CITY PLAN COMMISSION

FILE NUMBER: PLAT-25-000124

REQUEST: An application to replat a 2.071-acre tract of land containing part of Lot 3 in City Block A/6461 to create one lot on property located on Dairy Milk Lane at Zodiac Lane, southwest corner.

PLAT 25-000124

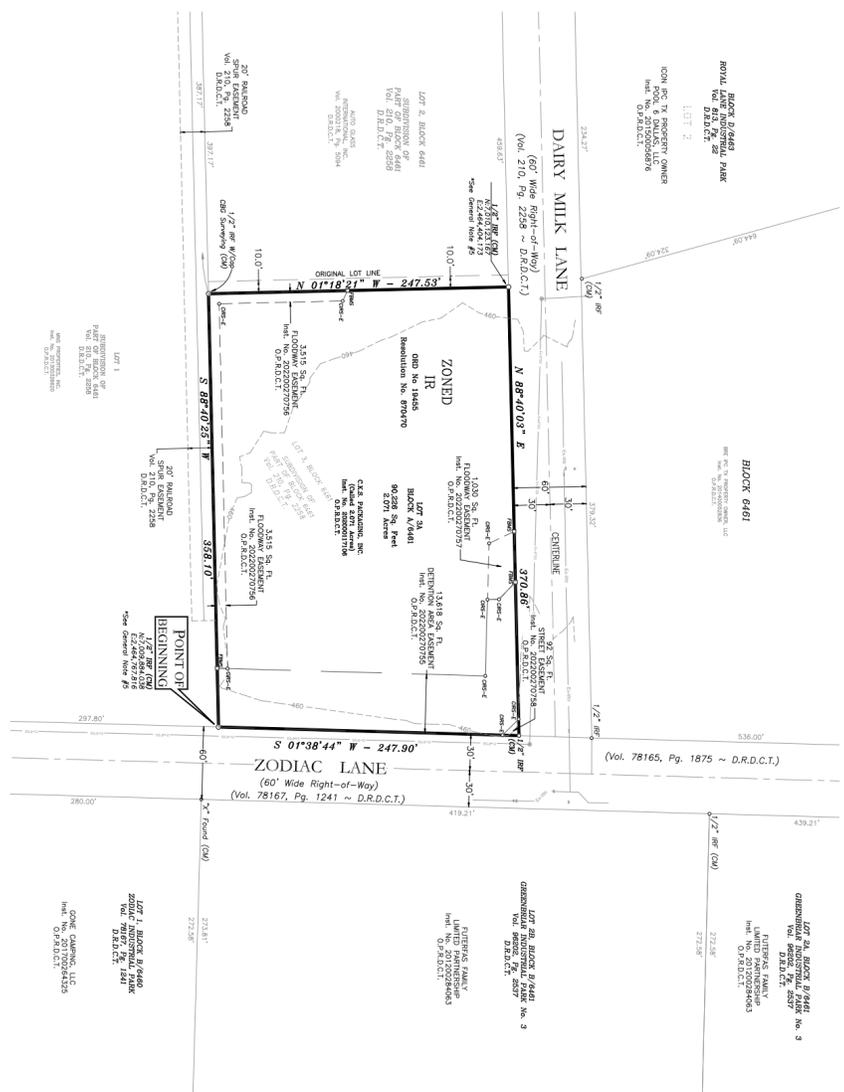
5. Any new or existing structure may not extend across new property lines. *Section 51A-8.503(e)*
6. On the final plat, all easement abandonments, and ROW abandonments must be by separate instrument with the recording information shown on the face of the plat. A release from the Real Estate Division is required prior to the plat being submitted to the Chairman for signature.

7. On the final plat, include two boundary corners tagged with these coordinates: "Texas State Plane Coordinate System, North Central Zone, North American Datum of 1983 on Grid Coordinate values, No Scale and no Projection."

8. On the final plat, monument all set corners per the Monumentation Ordinance. Prior to submittal of the final plat for the Chairman's signature. The monuments must be verified by the Chief City Surveyors Office in the Public Works Department. *Section 51A-8.617*

15. On the final plat, dedicate a minimum 5-foot by 5-foot corner clip (via fee simple or street easement) at the intersection of Dairy Milk Lane & Zodiac Lane. Section 51A 8.602(d)(1)
16. A larger corner clip may be requested during engineering plan and traffic review to accommodate an adequate turning radius, or to maintain public/traffic appurtenances, within the area of the corner clip. *Section 51A 8.602(d)(1), 51A 8.608(a)*
17. Plans must comply with sidewalk design standards: sidewalks must comply with a minimum five-foot width plus five-foot buffer.
18. Plans must comply with City's Street lighting standards. See illumination standards in Street Design Manual.

19. Prior to final plat, submit a completed final plat checklist and all supporting documents.
20. On the final plat, show recording information on all existing easements within 150 feet of the property.
21. On the final plat, chose a new or different plat name.

22. Additional design information is required for assessment. Site plan must be submitted showing proposed development, building finished floor elevation, development, existing mains – including downstream manhole, and proposed water and wastewater service locations. Submit water/wastewater engineering plans to 320 E. Jefferson Blvd., Room 200, Attention: Water and Wastewater Engineering.

23. Prior to the final plat, tree survey is required to be provided to the Arborist.
24. On the final plat, identify the property as Lot 3A in City Block A/6461.
